To: Brown, Anthony R (RM)[anthony.brown@bp.com]
Cc: Mike Johnson[mike.johnson@copperenv.com]; Greg Reller[gr@burlesonconsulting.com]; Cohen, Adam[Adam.Cohen@dgsllaw.com]; Wirtschafter, Joshua[Wirtschafter.Joshua@epa.gov]; Helmlinger, Andrew[Helmlinger.Andrew@epa.gov]; Cory Koger[Cory.S.Koger@usace.army.mil]; Chang, Kay SPK[Kay.Chang@usace.army.mil]; Lily Tavassoli (tavassoli.lily@epa.gov)[tavassoli.lily@epa.gov]; Doug Carey[douglas.carey@waterboards.ca.gov]; Black, Ned[Black.Ned@epa.gov]; Serda, Sophia[Serda.Sophia@epa.gov]; Yogi, David[Yogi.David@epa.gov]
From: Deschambault, Lynda
Sent: Thur 4/6/2017 10:03:01 PM
Subject: FW: Leviathan Mine Aspen Seep Bioreactor update

Subject: Leviathan Mine Aspen Seep Bioreactor update

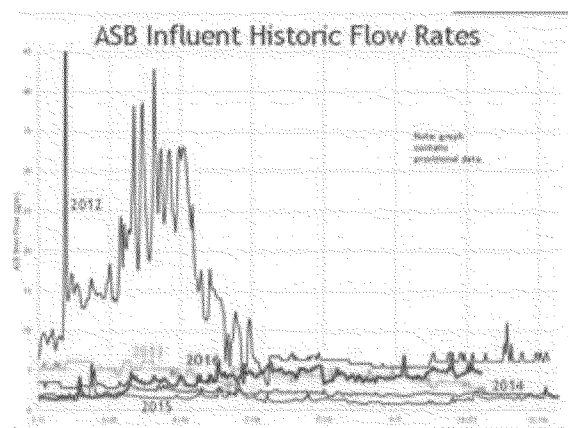
1) **Flow Rates:** Could you please provide some additional updates on charts and figures regarding flow, freeboard etc? For instance this one:
